FINAL DRAINAGE REPORT
FOR
LOT 9, CLAREMONT BUSINESS PARK
FILING NO. 2
EL PASO COUNTY, COLORADO

January 2018

Update to "PCD Project
PPR-18-007"

LOT 9 CBP			
PROPOSED DRAINAGE MAP			
PROJECT NO. 44-030	SCALE:	DATE: 1/25/2018	
DESIGNED BY: CMN	HORIZONTAL: 1"=20'	SHEET 1 OF 1	PDM
DRAWN BY: CMN	VERTICAL: N/A		
CHECKED BY: VAS

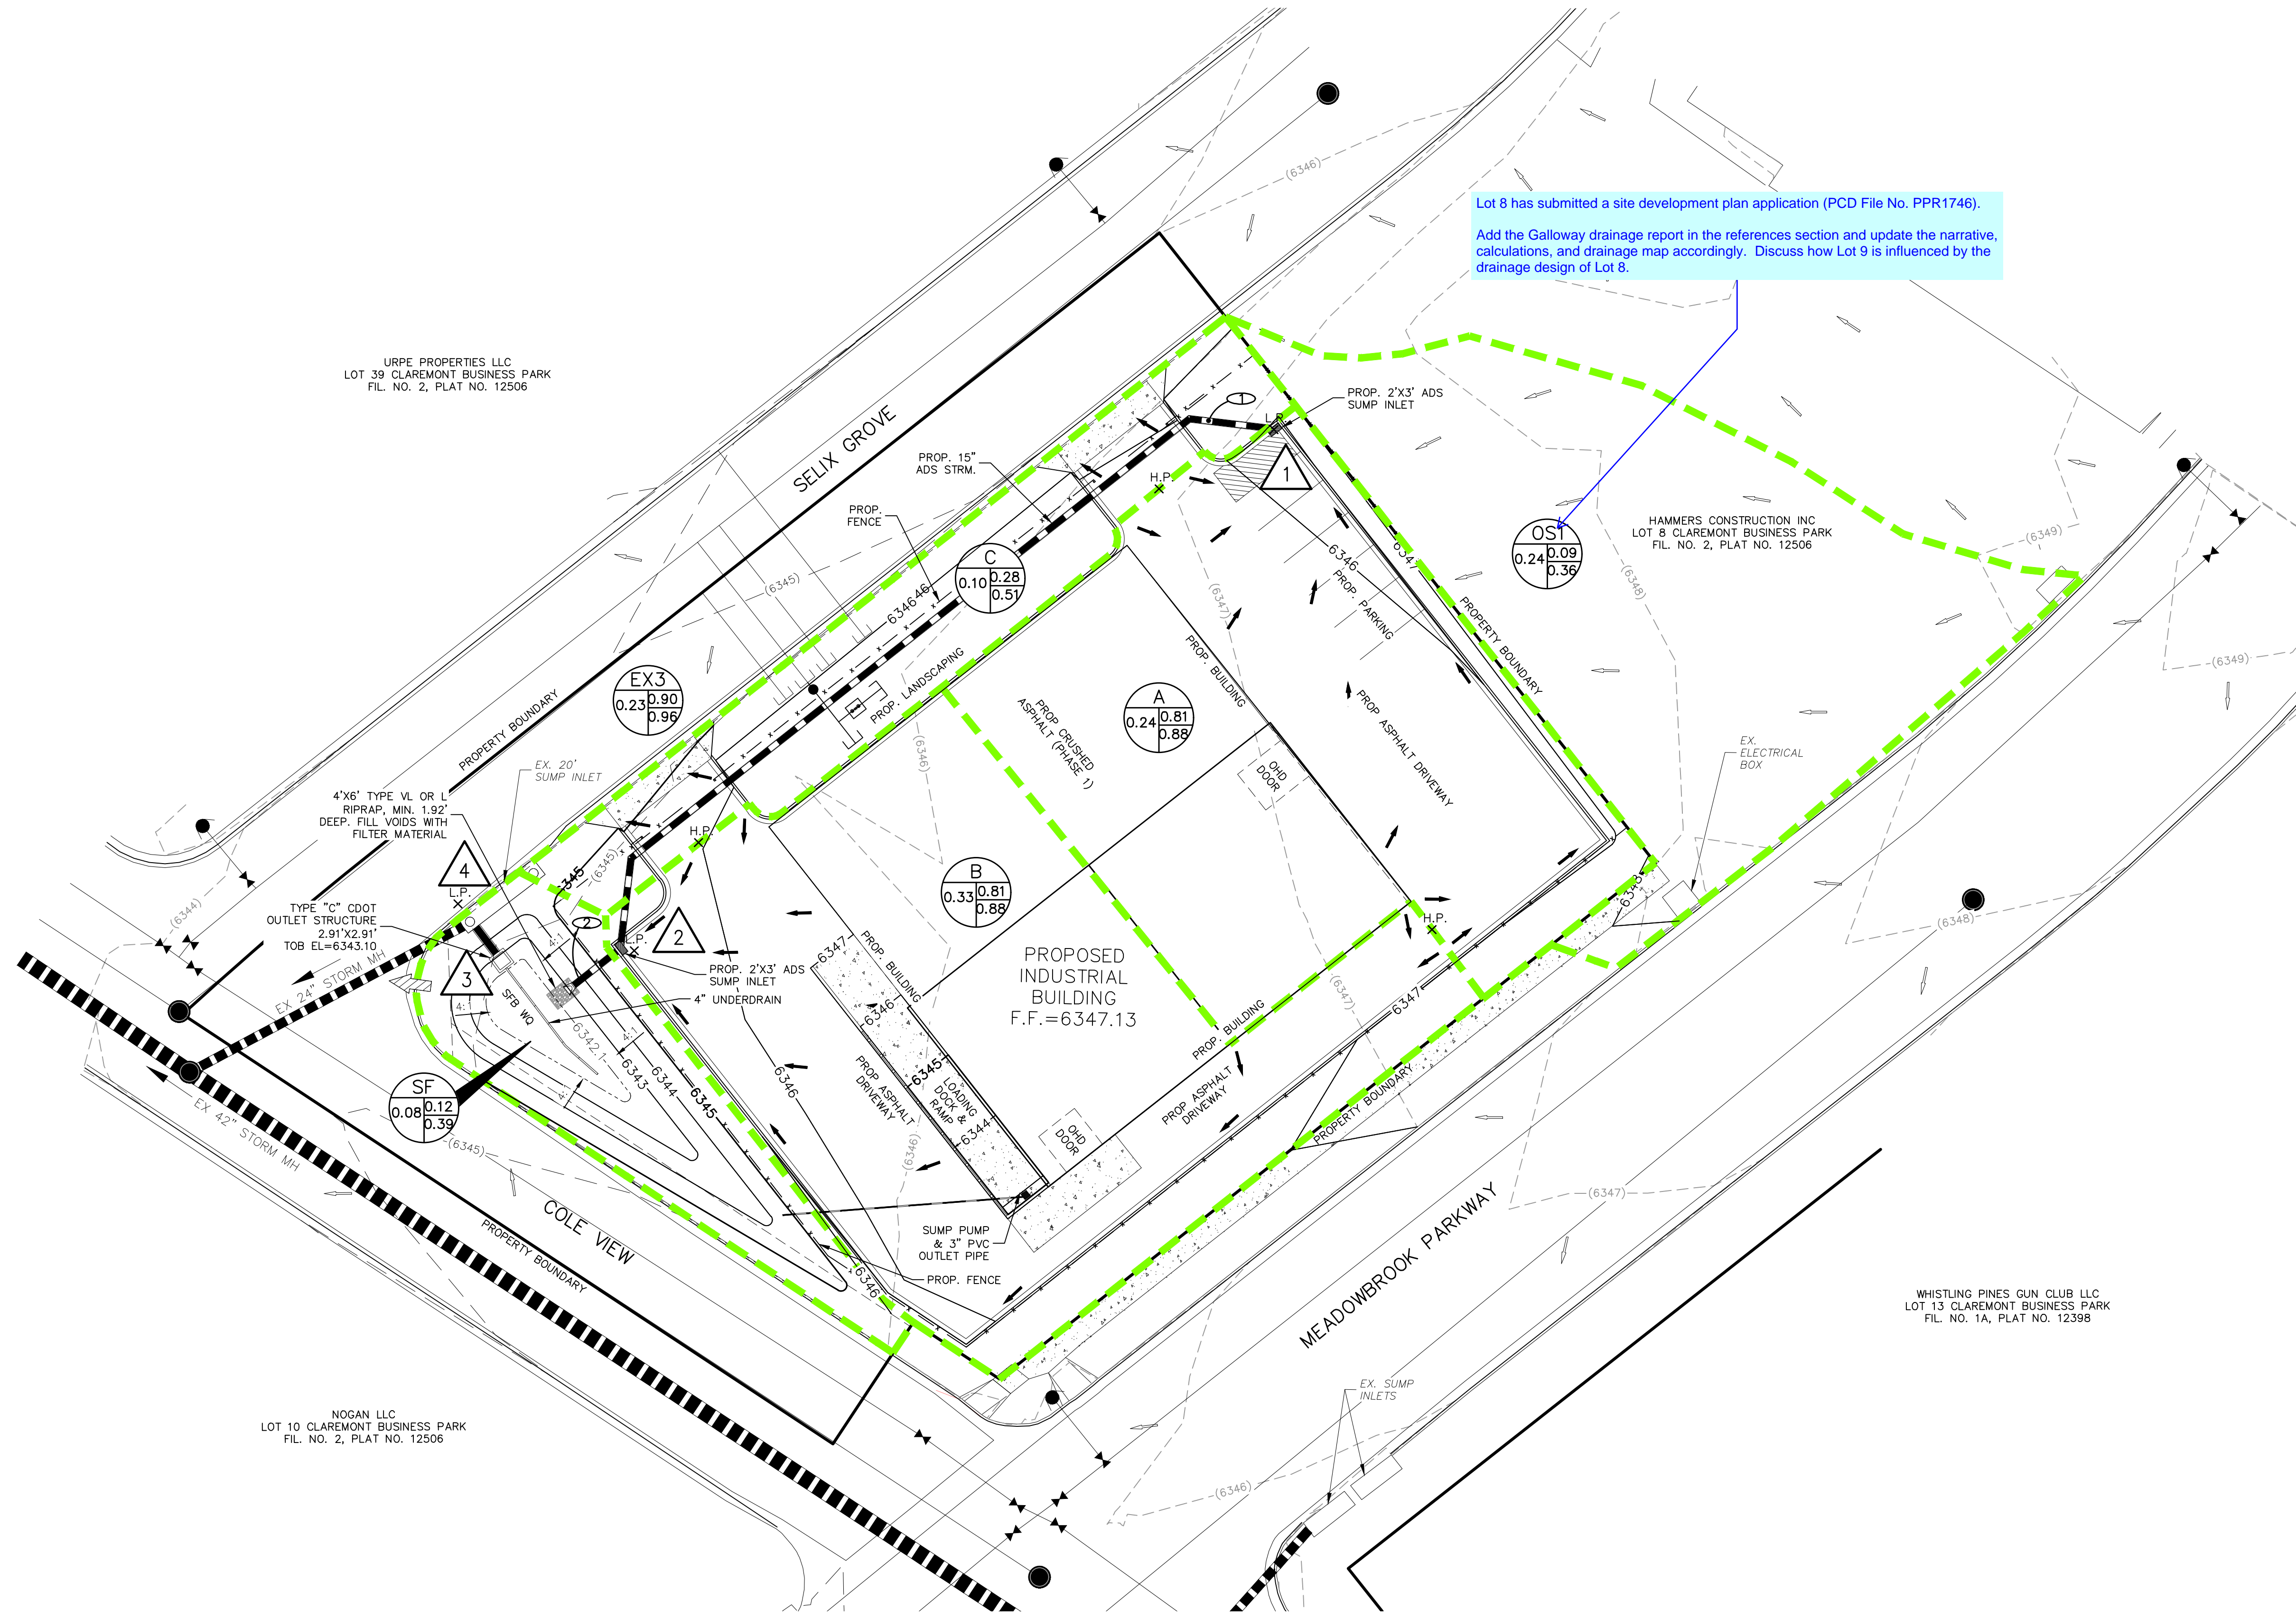
Lot 8 has submitted a site development plan application (PCD File No. PPR1746).
Add the Galloway drainage report in the references section and update the narrative, calculations, and drainage map accordingly. Discuss how Lot 9 is influenced by the drainage design of Lot 8.
